IFB No. IFB No. 22-24 HVAC Upgrades at Lathrop, Spring Creek and Bloom Schools

RE: ADDENDUM NO. 3

Subject : Addendum No. 003
To the Bid Documents For:
RPS IFB number 22-24
Spring Creek, Lathrop, & Bloom Elementary
HVAC Upgrades
Rockford, Illinois

M112

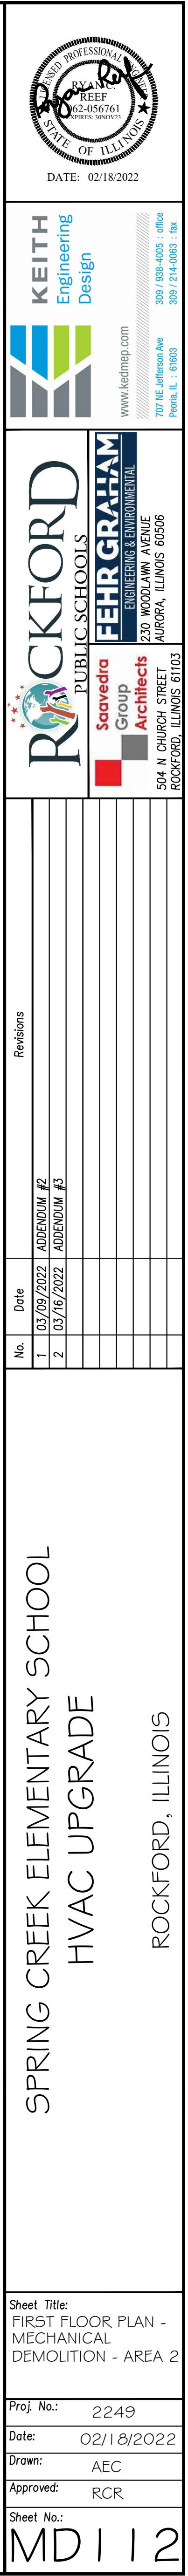
- a. Furnish and install new cabinet unit heater and associated branch piping located in vestibule as shown on attached sheet M112.
 - b. Furnish and install new DDC temperature sensor and associated wiring for CUH-7 located in vestibule as shown on attached sheet M112.

Sheet No.:
FD 102

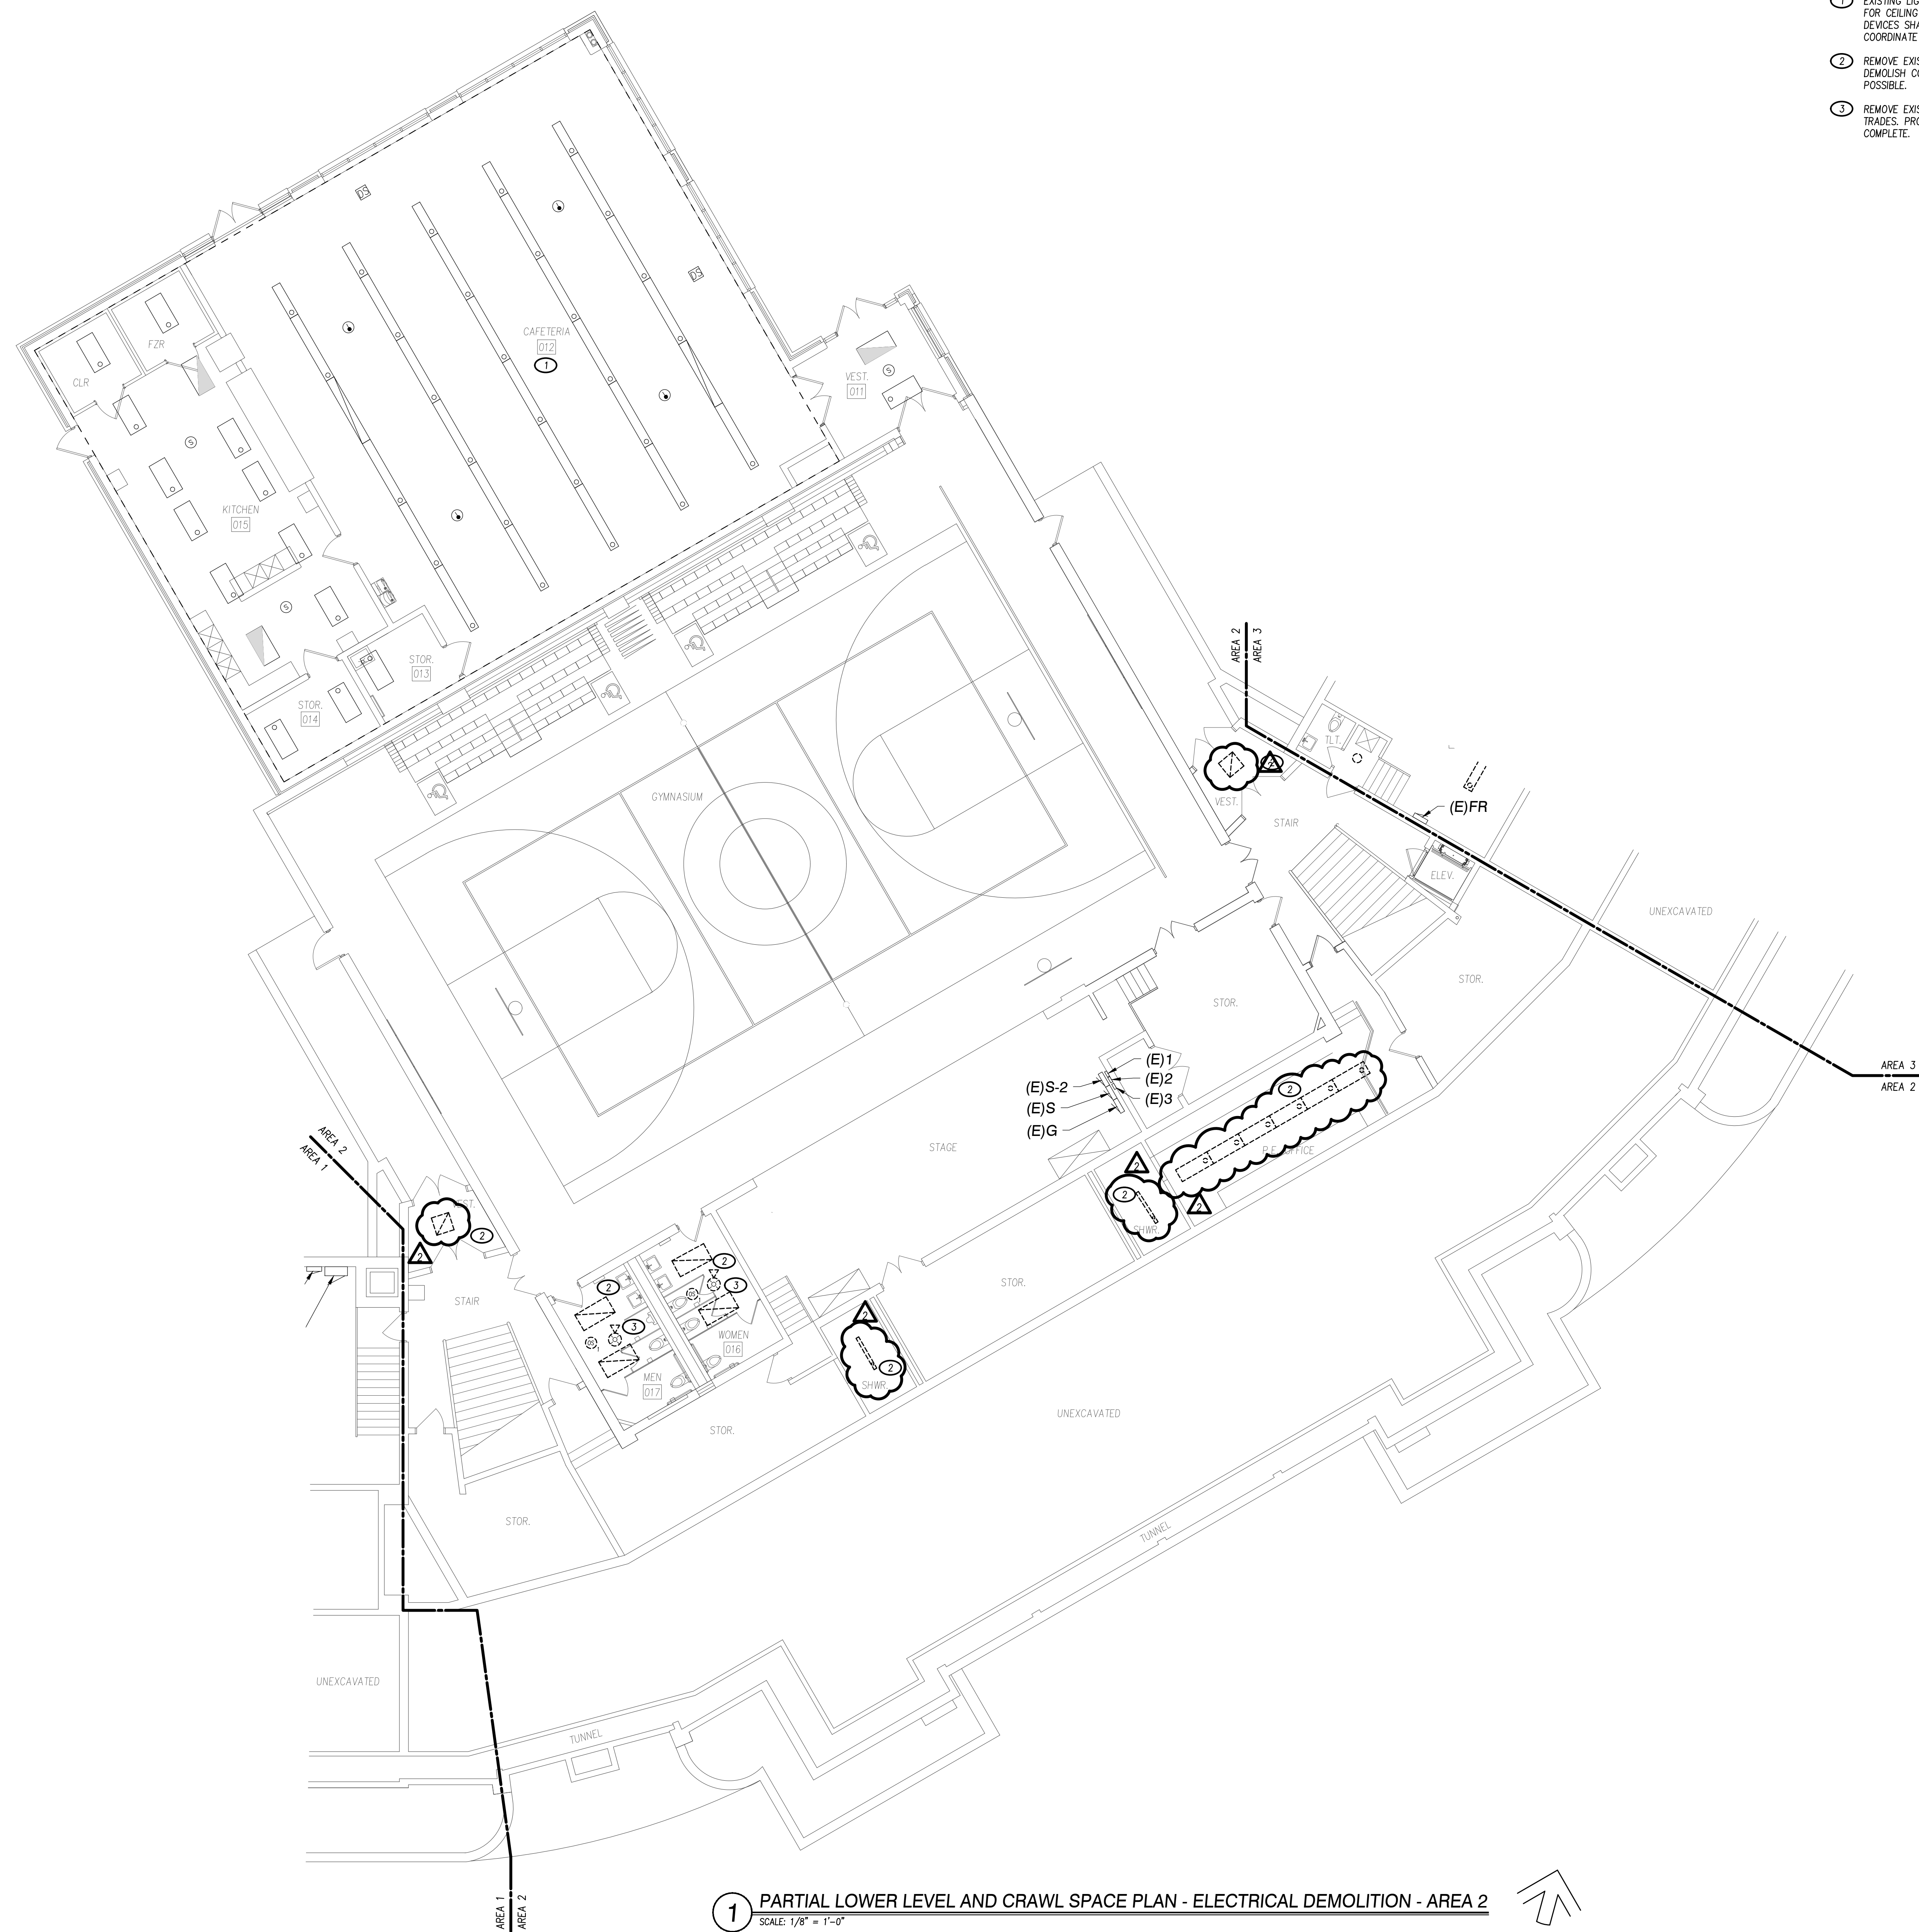
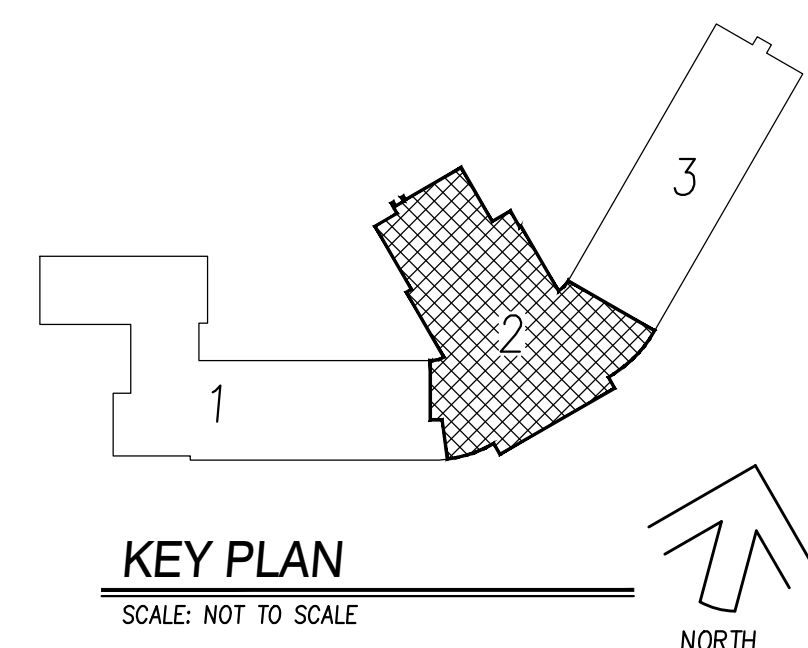
1. Drawing ED102 – Partial Lower Level and Crawl Space Plan – Electrical Demolition – Area 2
 - a. Demolish lighting in vestibules, showers, and PE office. Refer to sheet for further information

File No.:	2250
Date:	02/18/2022
Owner:	MARB
Approved:	BRK
Sheet No.:	E103

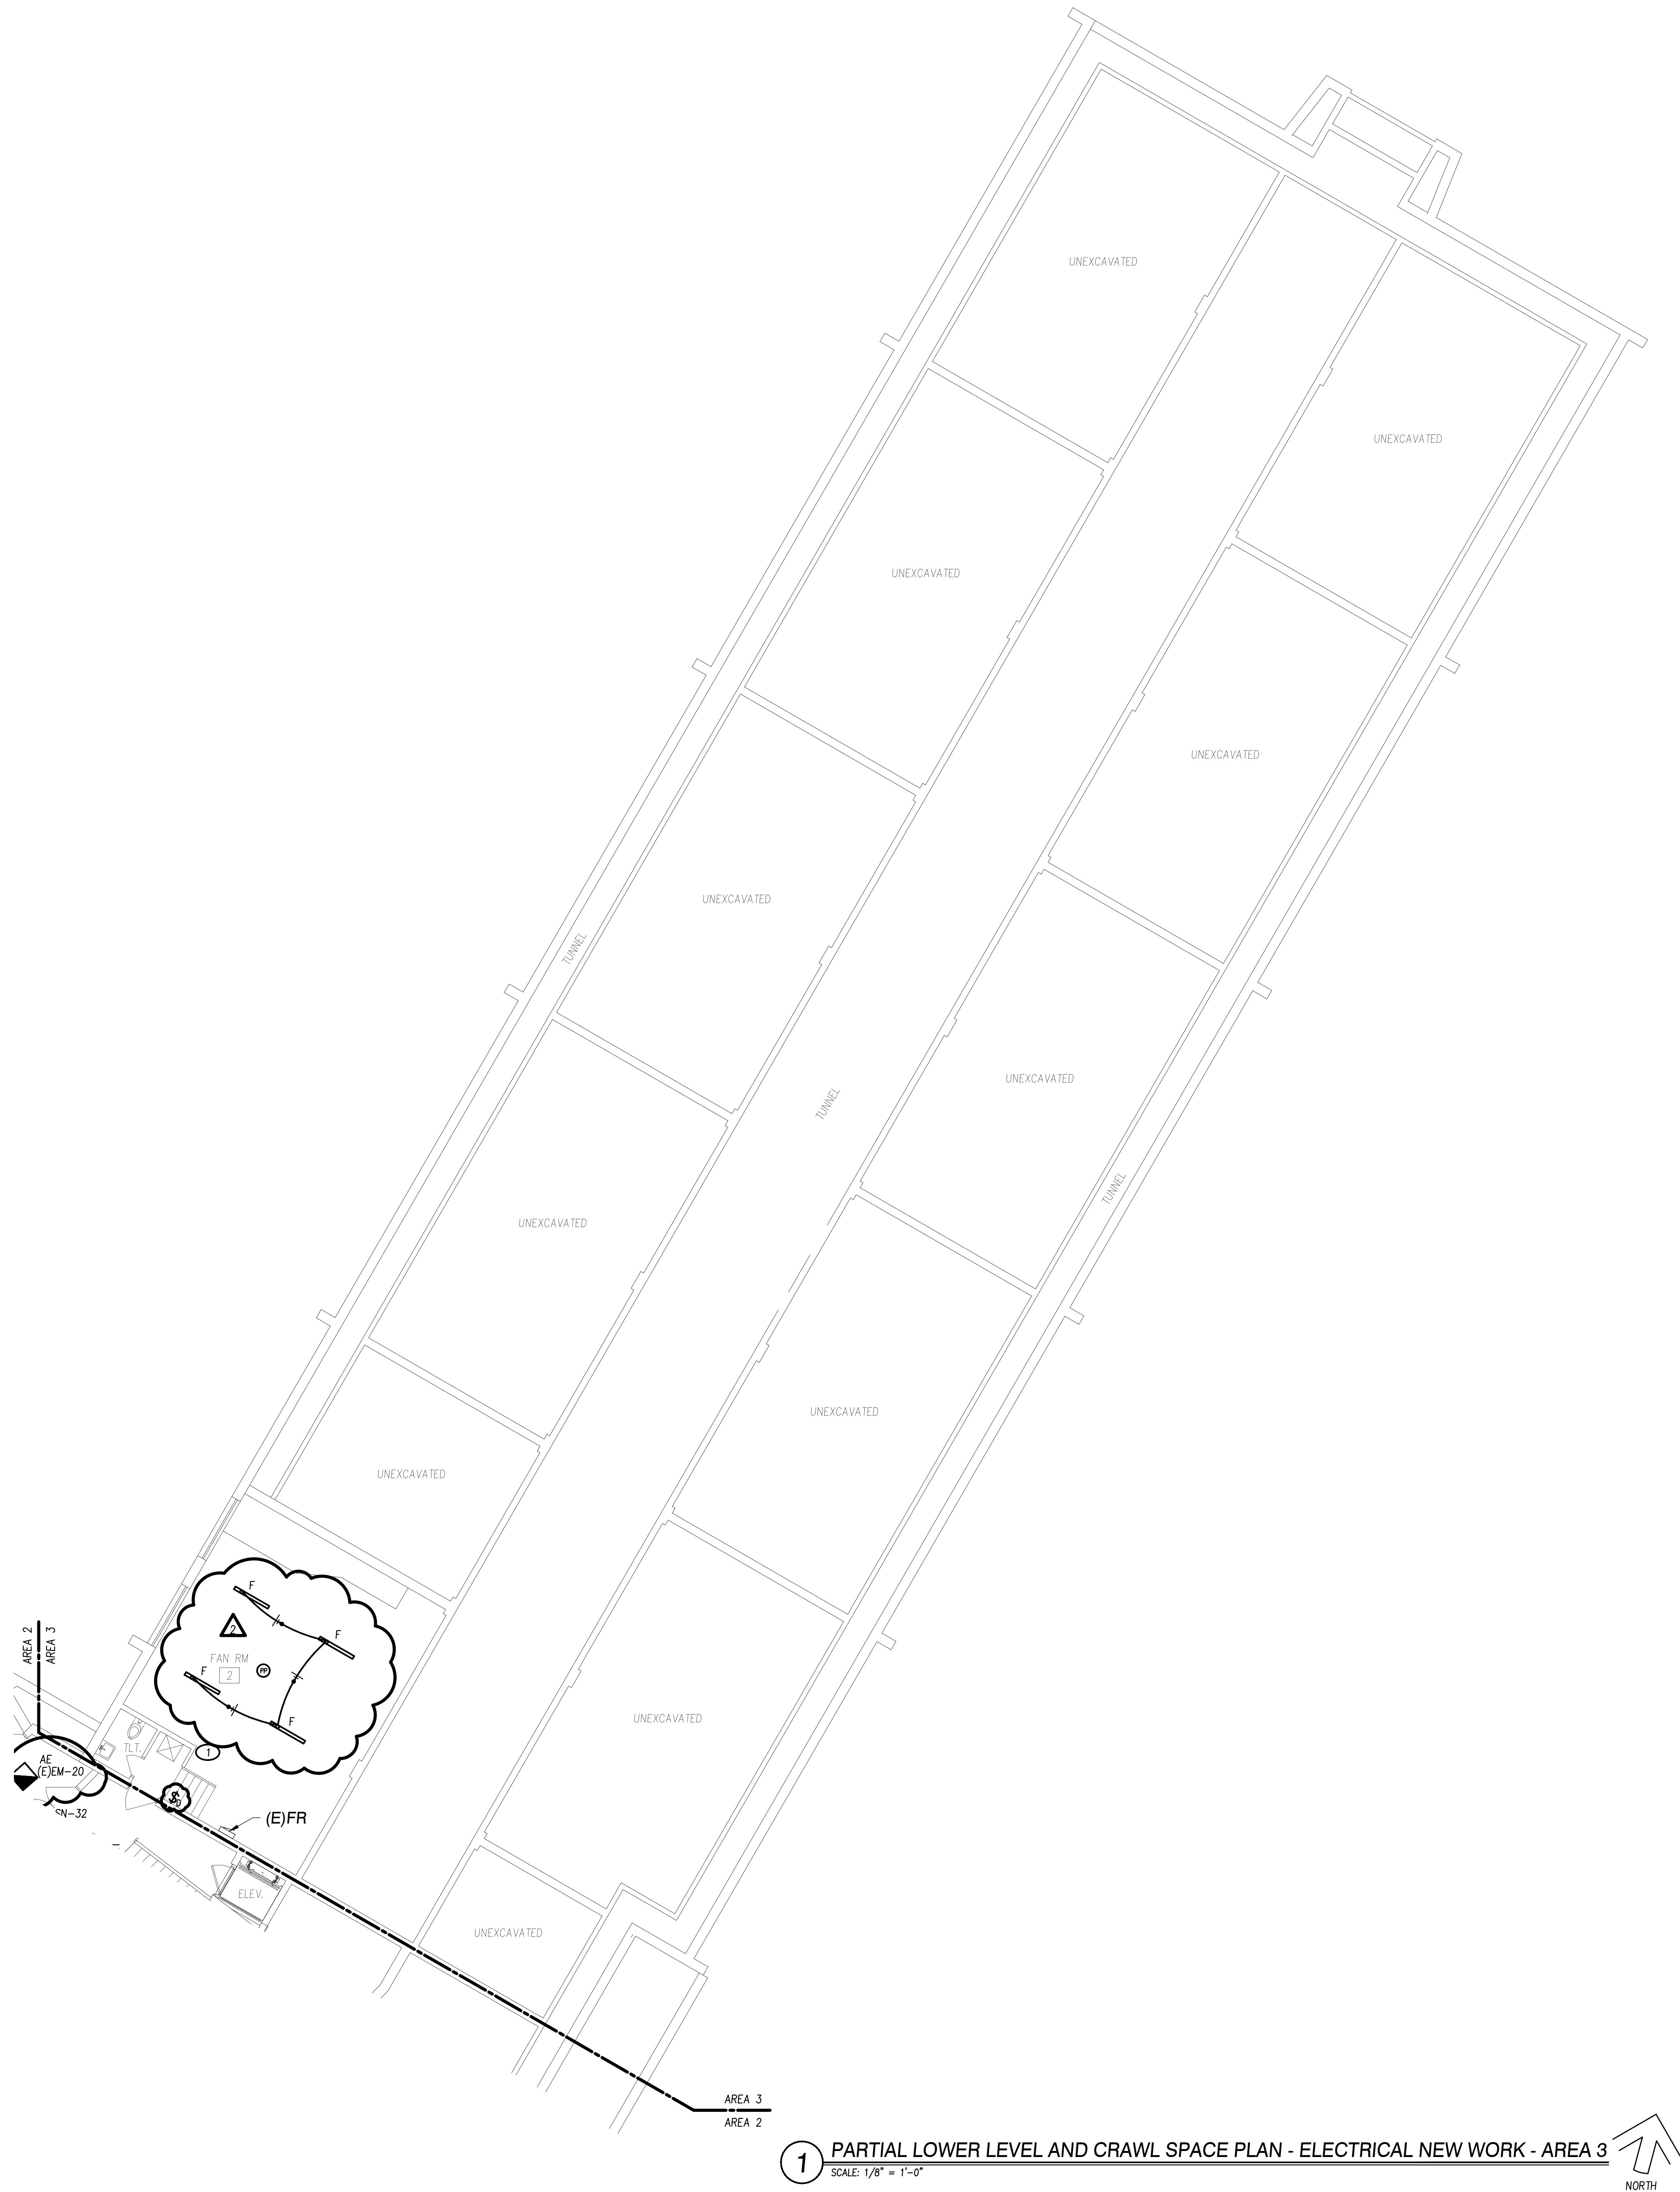
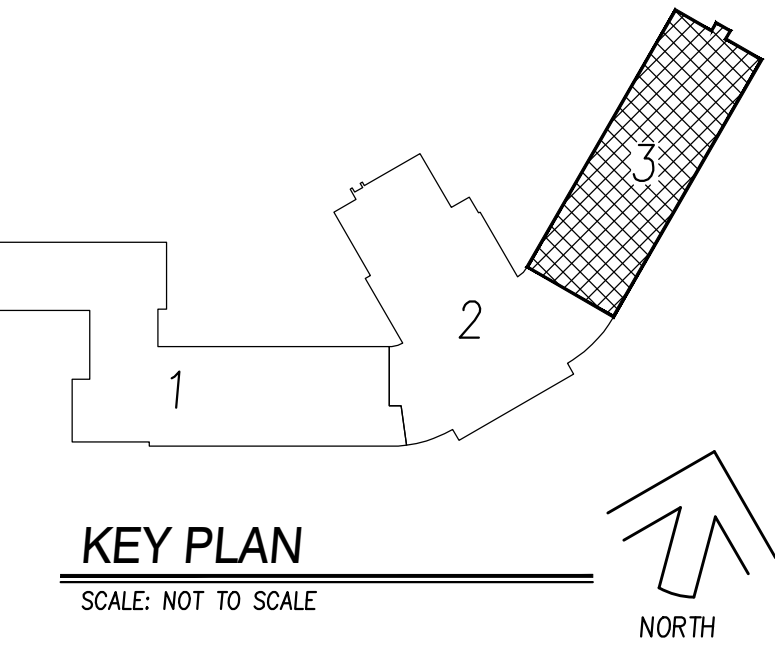
3. Drawing E103 – Partial Lower Level and Crawl Space Plan – Electrical New Work – Area 3
 - a. Furnish and install new lighting and switching in fan room. Fixture types have been corrected to fixture Type F. Refer to sheet for further information

Sheet No.: E112

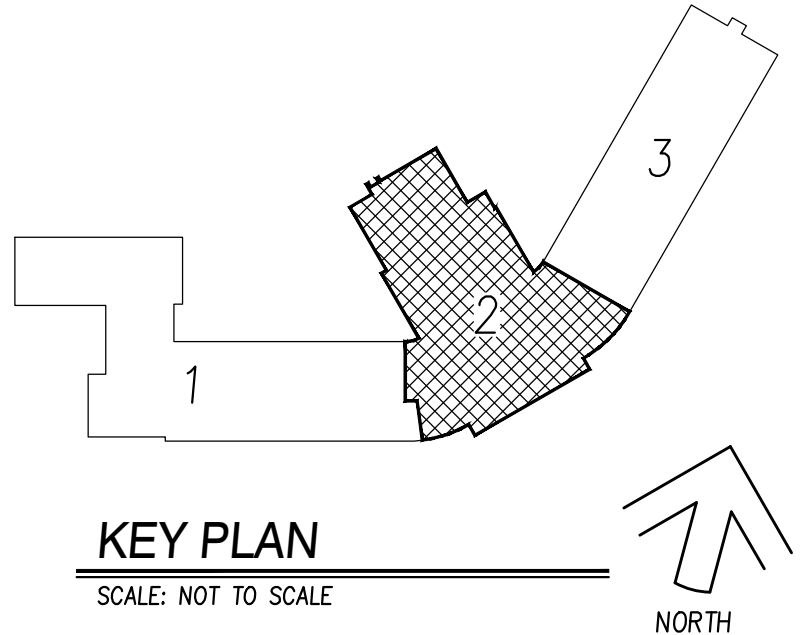
5. Drawing E112 – Partial First Floor Plan – Electrical New Work – Area 2
 - a. Furnish and install AHU accessory circuit for both air handling units. Circuit shall serve air handler lights. Refer to sheet for further information
